SERVICE DIRECTIVE BULLETIN NO. 0115

1. SUBJECT: Trim Relay Replacement

2. MODEL: All F-28F, 280F, and 280FX models equipped with 24 volt D.C. system;
Any F-28C, F-28C-2, or 280C models that have been converted to a 24 volt
D.C. system

Figure 1: Trim Relay (M83536/10-024M Relay Shown)

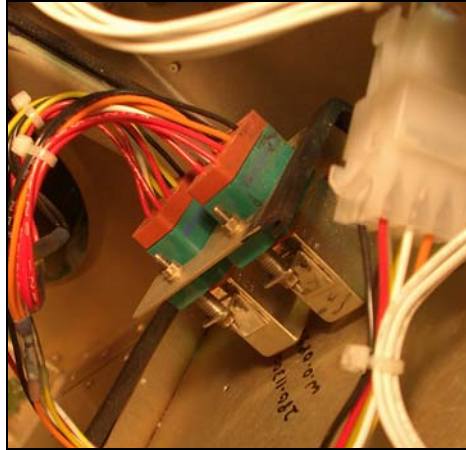
The cyclic trim system utilizes a P/N M83536/10-024M relay to control the trim actuator. This relay is manufactured by various companies under various manufacturers' part numbers. Enstrom has determined that the trim relay, P/N ES2100402BGM, manufactured by DRI Relays Inc. (DRI) has an unacceptably high failure rate. Trim relay P/N J-D4N-300M, manufactured by Leach Corporation (Leach), has performed more reliably.

DRI and Leach manufactured relays are installed in aircraft equipped with M83536/10-024M trim relays (Figure 1).

Within the next 25 hours, inspect the trim system for trim relays manufactured by DRI. If the trim relays are manufactured by DRI, replace with Leach manufactured relays.

Figure 2. Trim Relays (DRI relay shown on left; Leach relay shown on right)

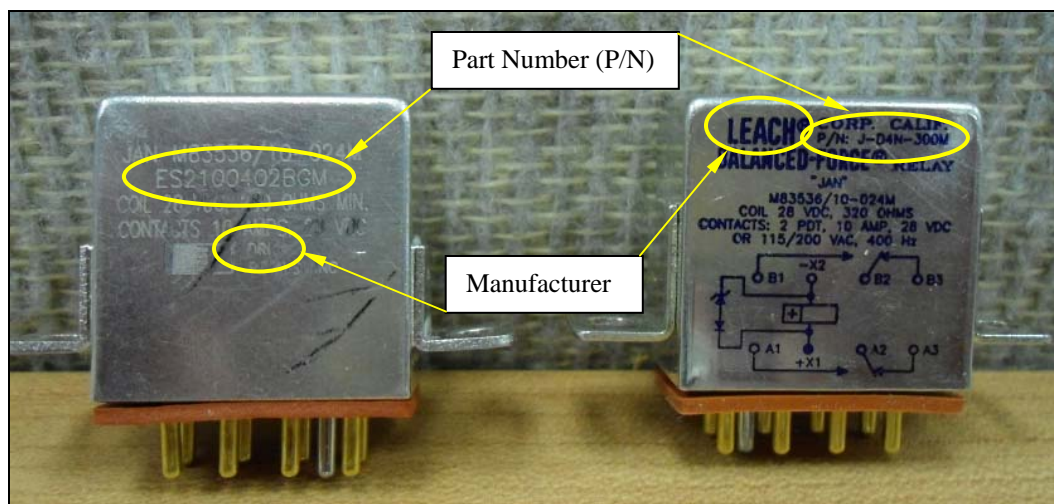
- A. Remove the seat deck and the copilot side floor panel for access to the trim relay assemblies.
- B. Inspect the trim relays (4 total) for the manufacturer information printed on the unit (Figure 2).
 - 1. If the trim relay is P/N ES2100402BGM, replace the relay with P/N J-D4N-300M.
 - 2. If the trim relay is P/N J-D4N-300M, no replacement is necessary.

- A. Remove the trim relay bracket.
- B. Remove the relay post nuts.
- C. Pull the relay from the socket.
- D. Install the replacement relay.
- E. Reinstall the nuts.
- F. Reinstall the bracket.
- G. Reinstall the copilot side floor panel and the seat deck.
